RESPONSE TO REQUEST FOR ADDITIONAL INFORMATION

US-APWR Design Certification

RAI NO.: NO. 1024-7053 REVISION 3
SRP SECTION: 03.08.03 – Concrete and Steel Internal Structures of Steel or Concrete Containments
APPLICATION SECTION: 3.8.3
DATE OF RAI ISSUE: 04/26/2013

QUESTION NO. 03.08.03-114:

Figure 03.08.03-114-1: Calculation of Baseplate Moment for SC Wall Basemat Anchorage

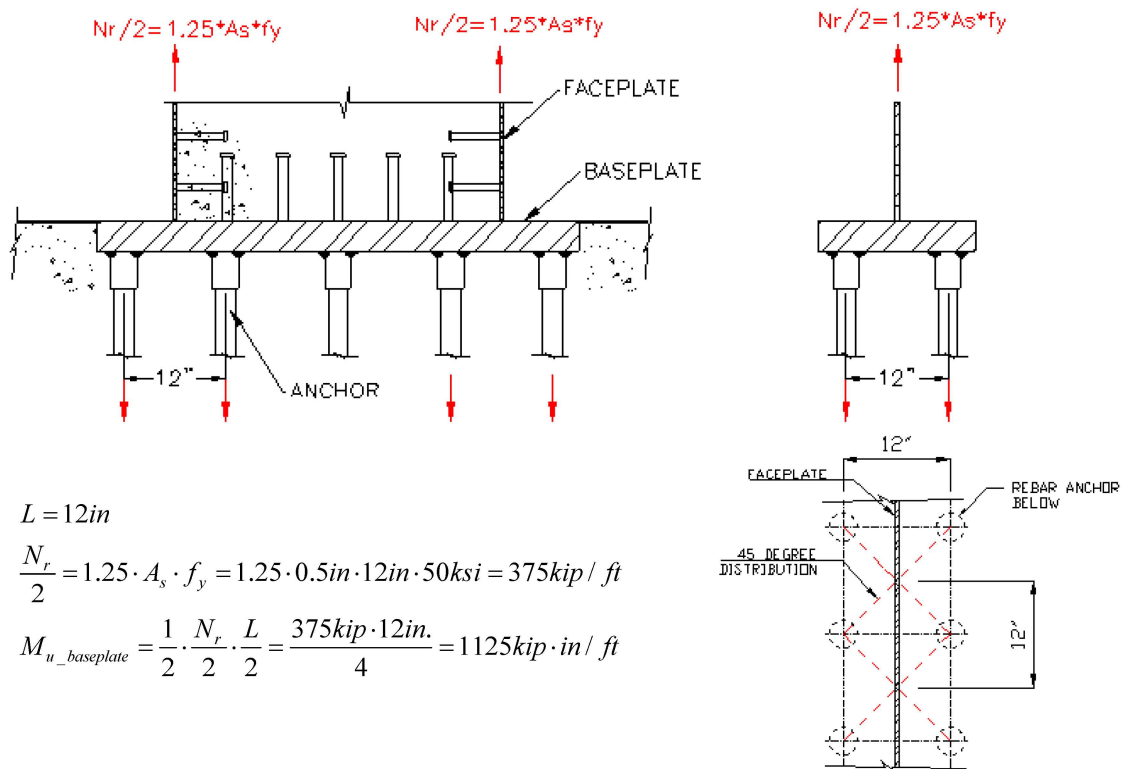
In the response to Item 3, the applicant indicated that the concrete supporting the 3.5 in. baseplate is more flexible than the steel plate in the steel to steel bolted plate connection, and the 10 ft. long #18 rebar anchors will undergo considerable stretching; therefore, prying action effects are neglected for the US-APWR steel concrete (SC) wall anchorage design. This explanation does not justify why baseplate flexibility would not occur for SC wall connections, since baseplate flexibility is a function of a number of design parameters that include the stiffness of the concrete, configuration of the baseplate (size and thickness), number and location of the anchors, edge distance, etc. Also, US-APWR DCD Section 3.8.4.2, which is referenced by Section 3.8.3.2 of the DCD, indicates that RG 1.199 (November 2003) will be used in the design of anchorage to the concrete structure. Regulatory Position 5 of RG 1.199 states that, "Loads and forces on embedments should be properly evaluated to account for baseplate flexibility ..." Therefore, the staff requests that the applicant specify that the design basis identified in the DCD, with respect to RG 1.199, will be followed, and thus, baseplate flexibility will be considered unless it is clearly demonstrated to be not applicable for particular connection designs.

The manner in which baseplate flexibility has been addressed in the steel concrete (SC) wall basemat anchorage connection is in accordance with United States industry practice for steel baseplate design, as represented in American Institute of Steel Construction (AISC) Design Guide 1, "Base Plate and Anchor Rod Design" (2nd Edition.) This practice accounts for specific design parameters such as the baseplate size and thickness and the number and location of the anchors relative to the connected member. Section 3.2 of AISC Design Guide 1 states that neglecting prying forces in anchor rods is "usually justified when the baseplate thickness is calculated assuming cantilever bending about the web and/or flange of the column section, as described in Step 3". Step 3 states, "For tensile loads, a simple approach is to assume the anchor rod loads generate bending moments in the baseplate consistent with cantilever action about the web or flanges of the column section (one-way bending)" and that "the effective bending width for the baseplate can be conservatively approximated using a 45° distribution from the centerline of the anchor rod to the face of the column flange or web." As illustrated in Figure 03.08.03-114-1 below, this is the methodology used for the containment internal structure (CIS) SC wall basemat anchorage connections to conservatively calculate the baseplate moment demand that is used to determine the required baseplate thickness. It is noted that the anchors resisting tension are arranged symmetrically with respect to the SC wall faceplate. The calculation using the moment developed in the figure results in a baseplate thickness of 3.5 in.

Importantly, the baseplate thickness calculation has also been performed in accordance with the full strength design methodology, wherein all connectors such as the baseplate are required to transfer the full expected strengths of the connected SC wall. In accordance with Technical Report MUAP-11020, Rev. 1, Section 3.1, the required tensile strength (N_r)
